STATE OF MAINE
 DEPARTMENT OF TRANSPORTATION
 16 STATE HOUSE STATION
 AUGUSTA, MAINE 04333-0016

February 6, 2023
 Subject: Acadia Gateway
 State WIN: 017163.03
 Location: Trenton
 Amendment No. 9

Please make the following changes to the Bid Documents:

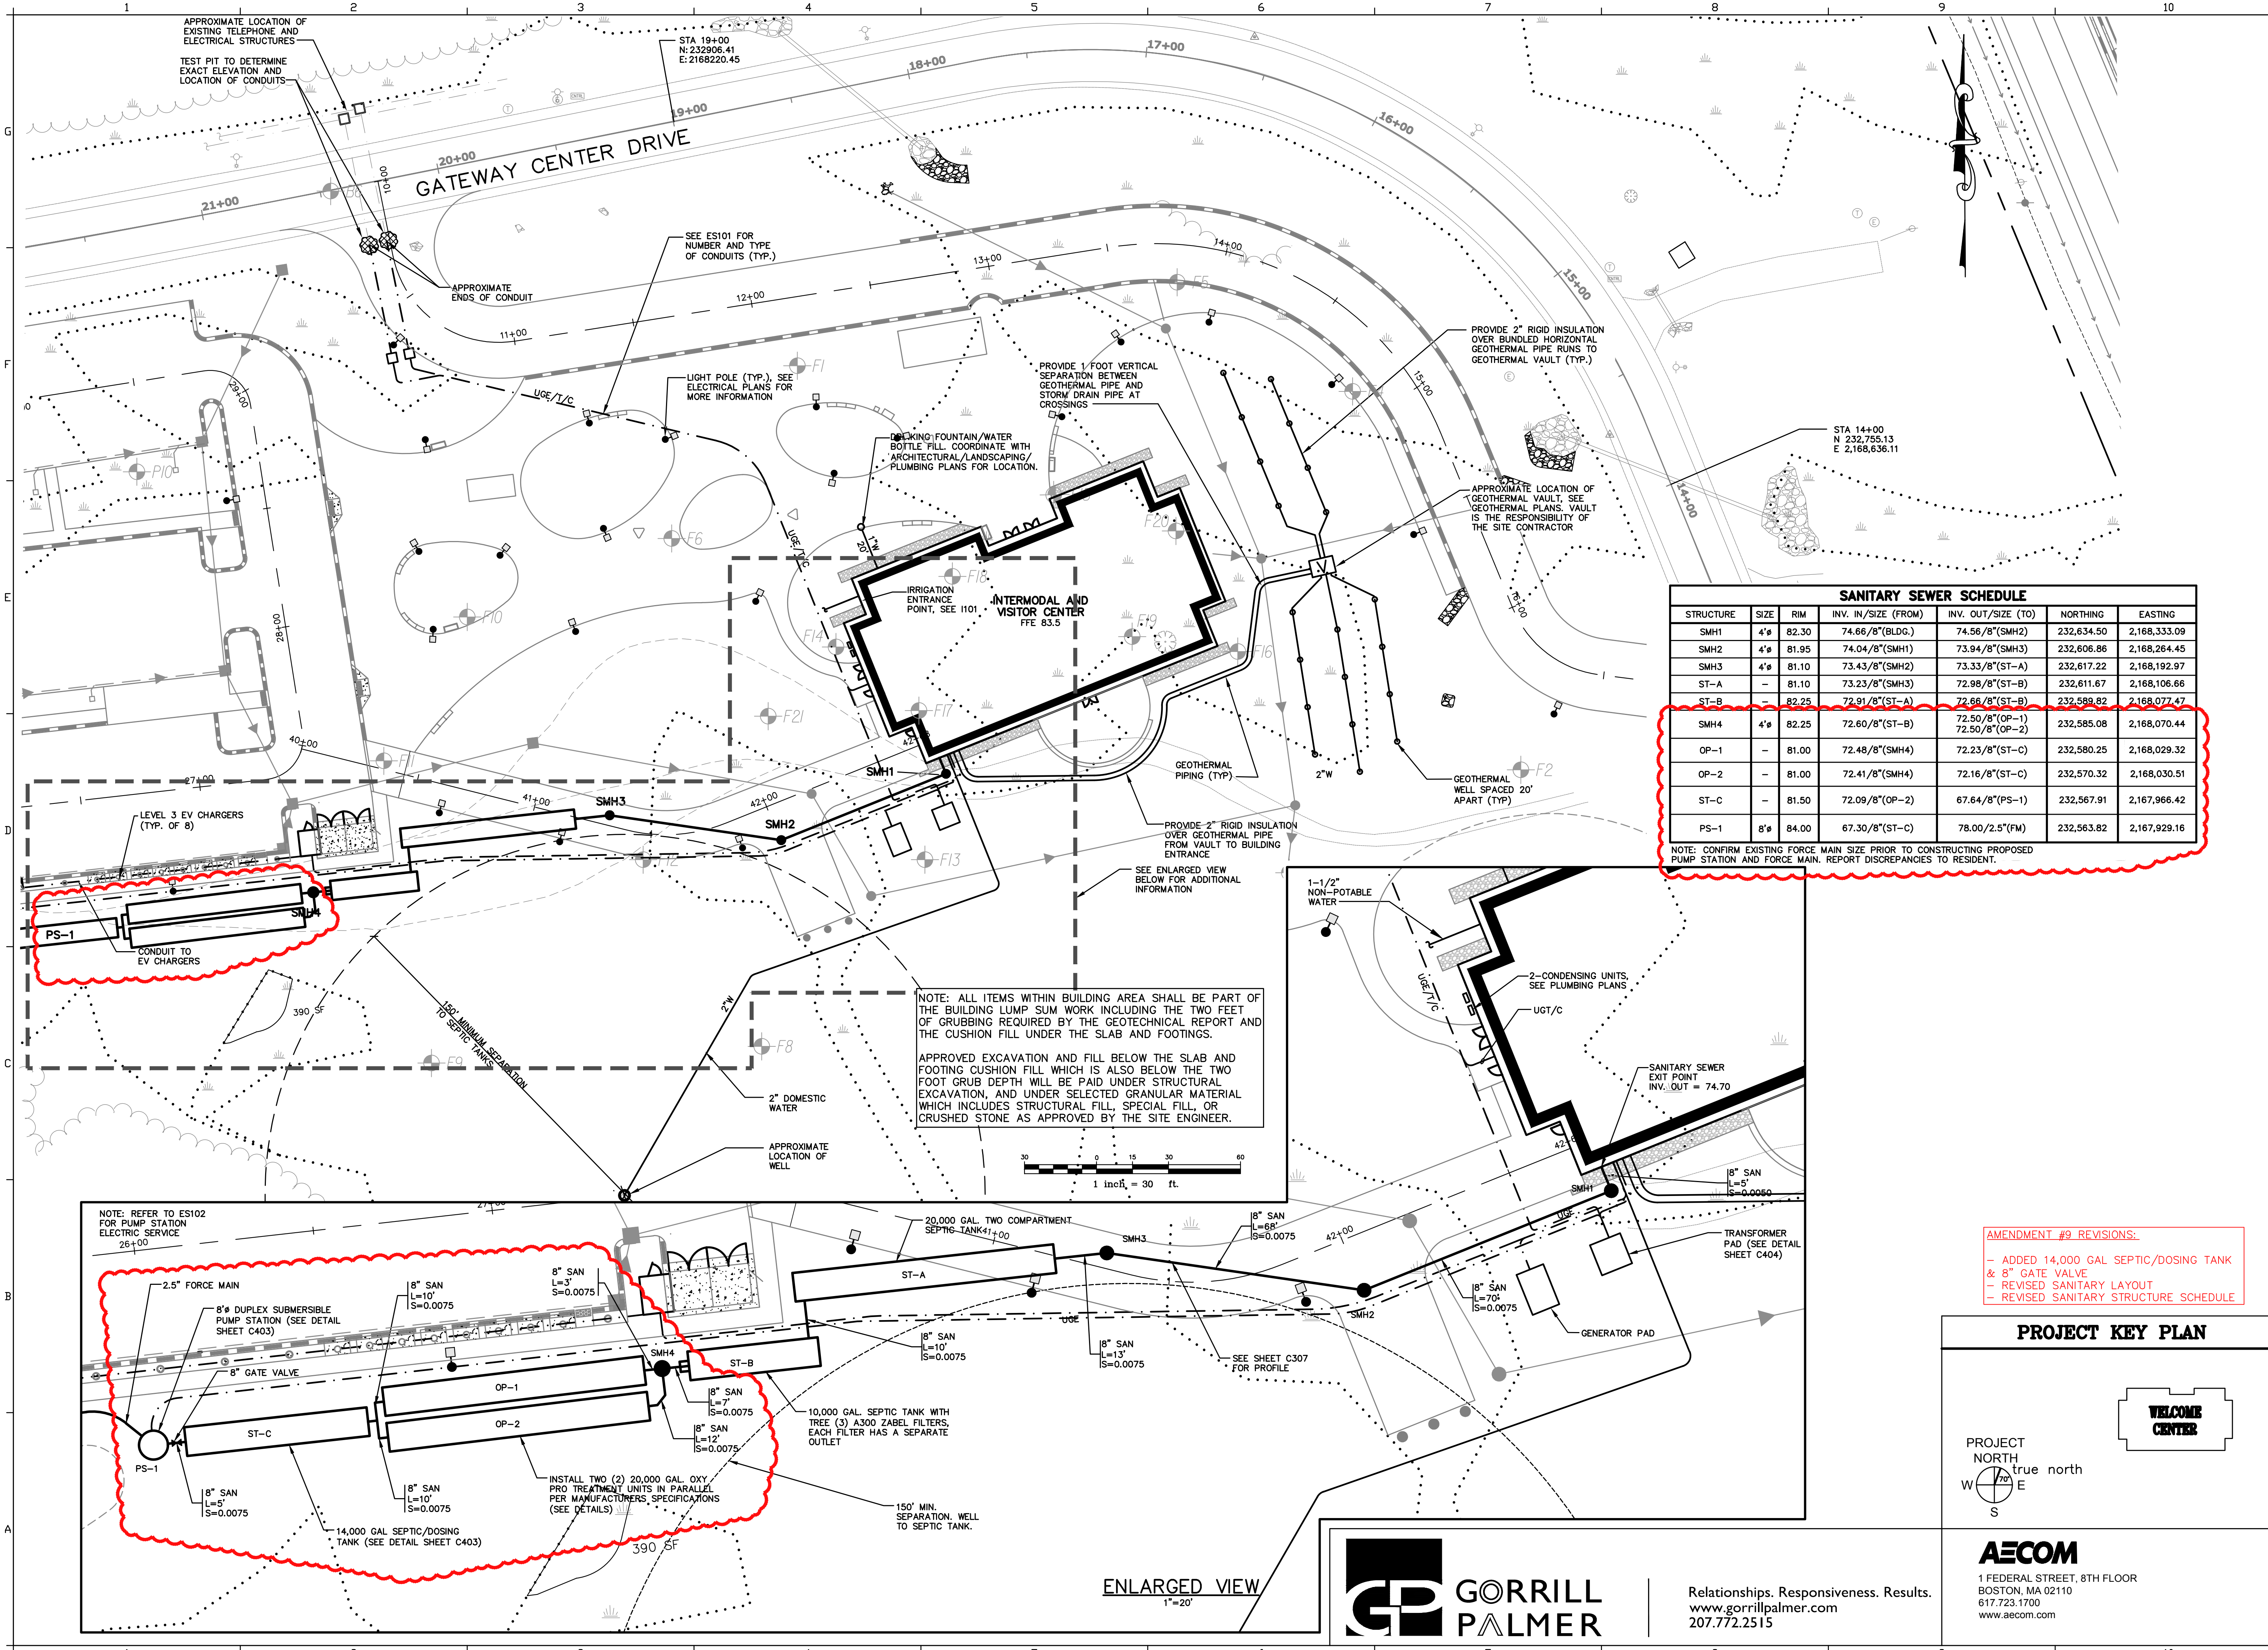
AMENDMENT #9 REVISIONS:

- ADDED 14,000 GAL SEPTIC/DOSING TANK & 8" GATE VALVE
- REVISED SANITARY LAYOUT
- REVISED SANITARY STRUCTURE SCHEDULE

UTILITY PLAN - EAST

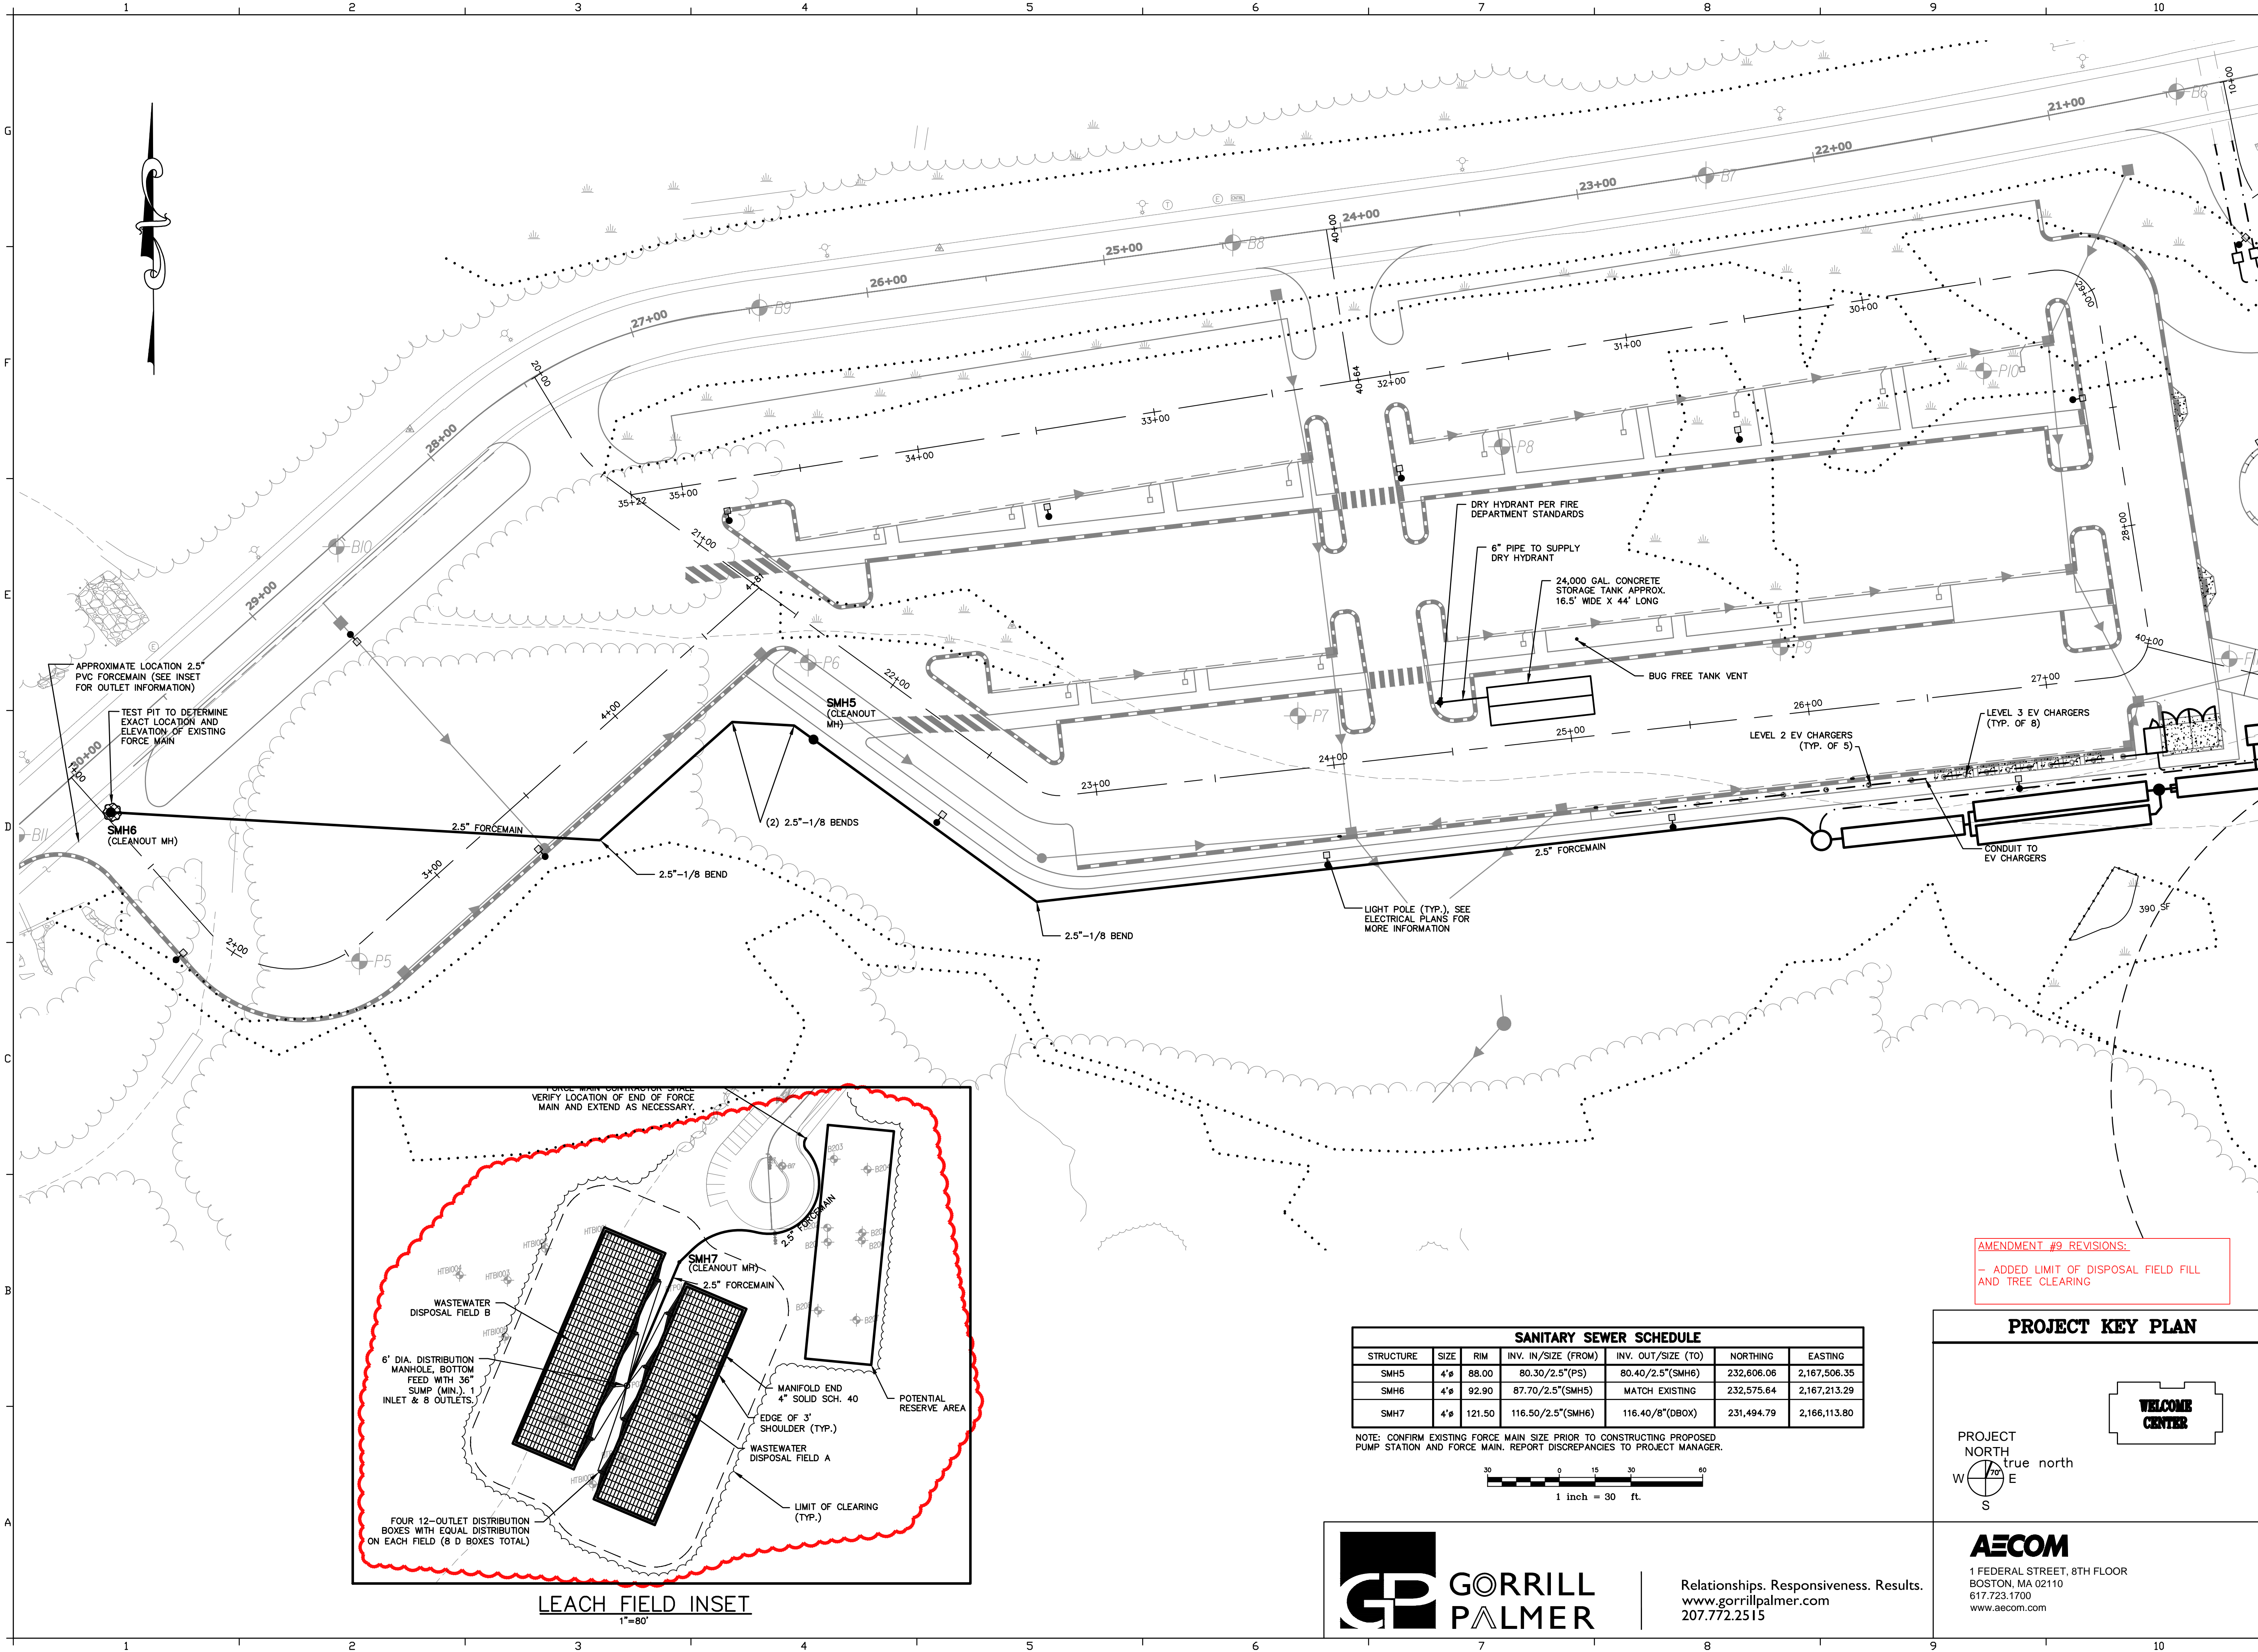
Question: Is it the intent of the Department to clear the potential reserve area of the disposal field? Are borings available for the parking lot disposal fields?

AMENDMENT #9 REVISIONS:
 - ADDED LIMIT OF DISPOSAL FIELD FILL AND TREE CLEARING

Response: Yes, the intent is to clear the reserve disposal field during construction as shown on the revised sheet C203. There are no disposal fields in the parking lot areas.
